# Access Compliance Report

## Public Rights-of-Way

Intersection ID: 46811	Main Street: ARBOR_VISTA_DR	Cross Street: ROSE_CREEK_CT	Location:	N
ADA ID: FA07769BD1A2	Ramp Type: PerpDiag	Initial Pass/Fail: Fail	Overall Compliance: No	Severity Score: 8.75
Codes/Mitigation Info/Possible Solution		Field Measurements/Component Compliance

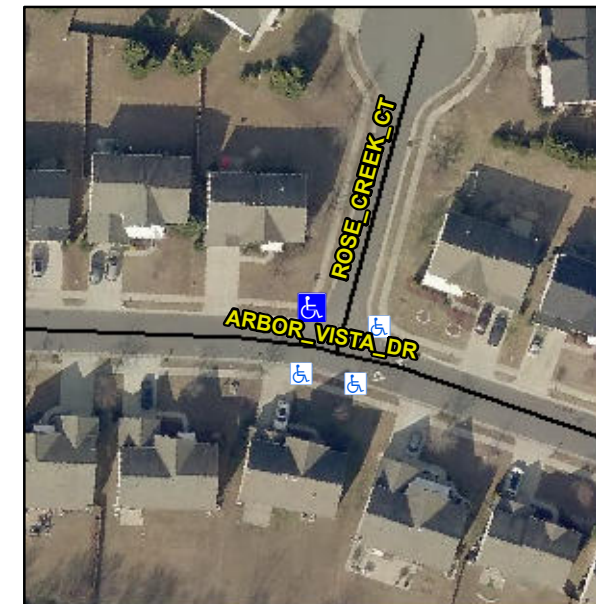
**Not Found, R304.5.1**

Compliance	Description	Data	Compliance	Description	Data
N/A	Ramp Length (in)	50.0	Yes	Ramp Slope (%)	6.8
No	Ramp Width (in)	36.0	Yes	Ramp XSlope (%)	1.8
N/A	Flare Type LT	N/A	N/A	Flare Type RT	N/A
N/A	Flare Slope LT (%)	N/A	N/A	Flare Slope RT (%)	N/A
N/A	Flare Traversable LT?	N/A	N/A	Flare Traversable RT?	N/A
N/A	Landing Length (in)	N/A	N/A	DWS Provided?	N/A
N/A	Landing Width (in)	N/A	N/A	DWS Contrast?	N/A
N/A	Landing Slope (%)	N/A	N/A	DWS Length (in)	N/A
N/A	Landing X Slope (%)	N/A	N/A	DWS Full Width?	N/A
N/A	Landing Curb? (Y/N)	N/A	N/A	DWS Offset (in)	N/A
N/A	Shared Landing?	N/A			
N/A	Gutter Ponding?	N/A	N/A	Gutter Slope (%)	N/A
N/A	Gutter Lip Ht (in)	N/A	N/A	Gutter X Slope (%)	N/A
N/A	Painted X Walk1?	No	N/A	Painted X Walk2?	No
	X Walk 1 Direction	To SW		X Walk 2 Direction	To SE
N/A	X Walk 1 Width (in)	N/A	N/A	X Walk 2 Width (in)	N/A
	X Walk 1 Slope (%)	0.6		X Walk 2 Slope (%)	1.5
	X Walk 1 X Slope (%)	0.9		X Walk 2 X Slope (%)	0.1

**Remove & Replace Curb Ramp With Two New Directional Ramps or Equivalent.**
